HOLDOVER
REVISED
MAWSS PARKING PLAZA SUBDIVISION

APPLICATION NUMBER Holdover DATE April 3, 2003

APPLICANT MAWSS Parking Plaza Subdivision

MAWSS PARKING PLAZA SUBDIVISION

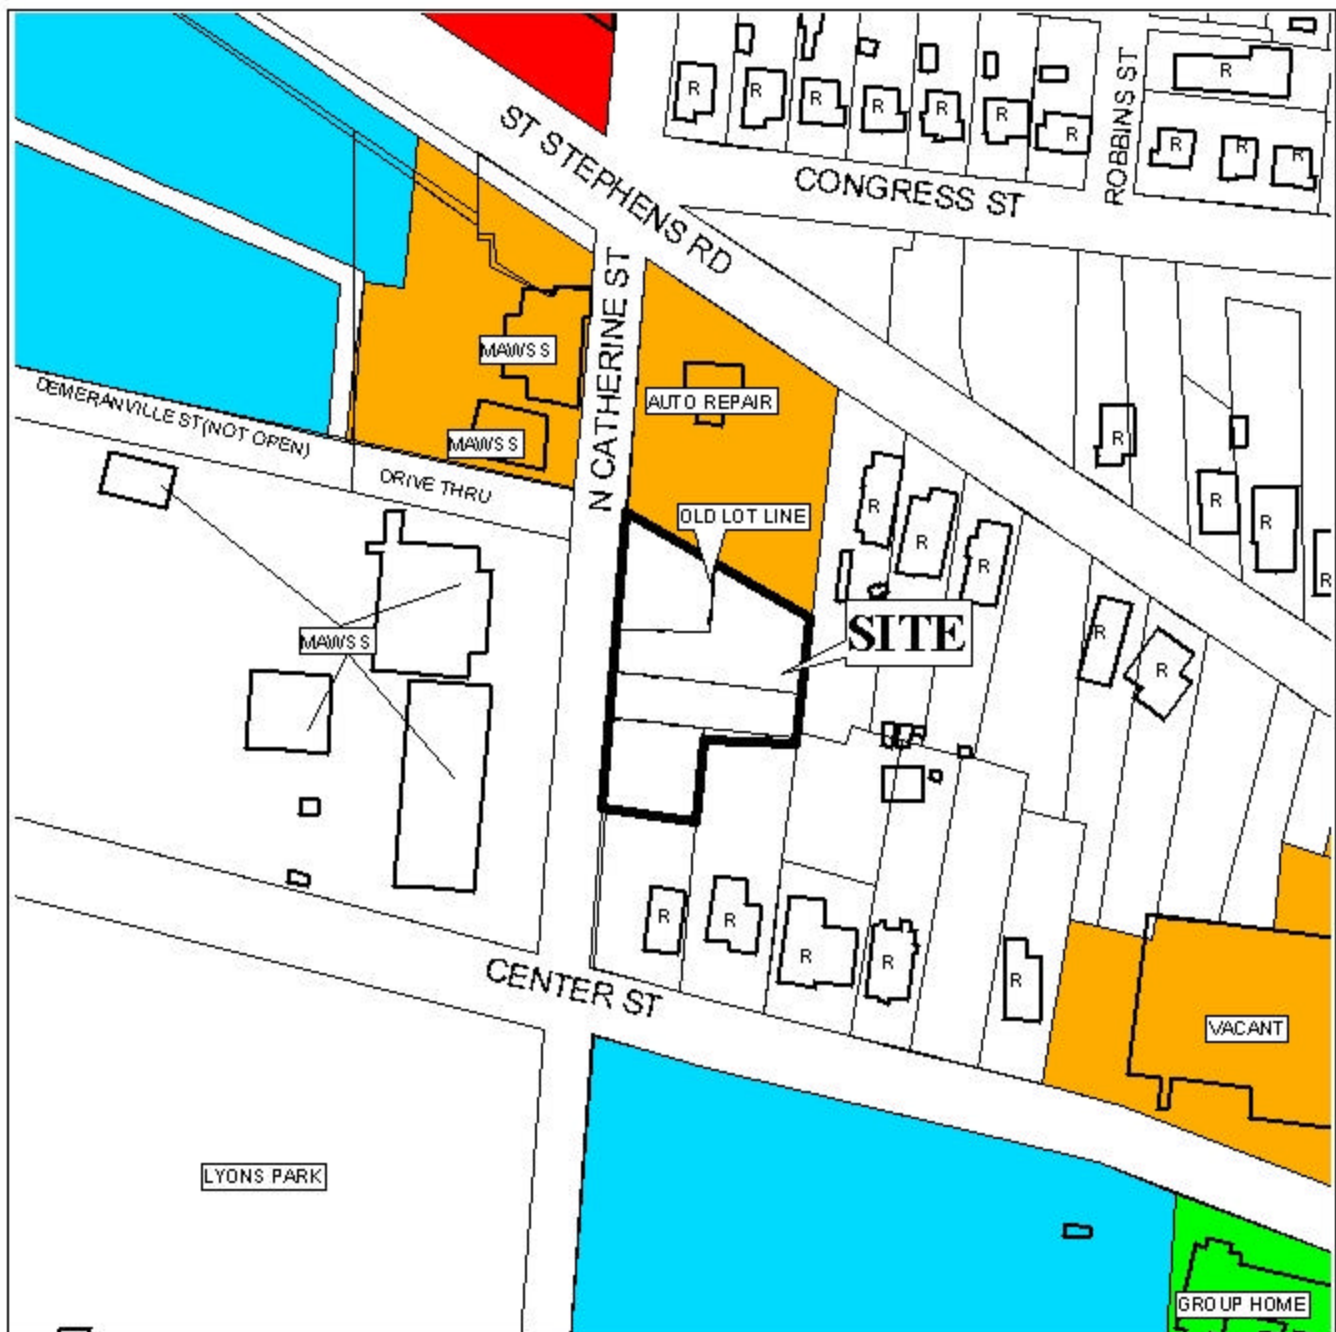
With this being a commercial subdivision, a buffer in compliance with Section V.A.7 of the Subdivision Regulations, should be required where the site adjoins residential property.

The plat meets the minimum requirements of the Subdivision Regulations and is recommended for Tentative Approval subject to the following condition: 1) the placement of a note on the final plat stating that a buffer, in compliance with Section V.A.7. of the Subdivision Regulations, will be provided where the site adjoins residential property.
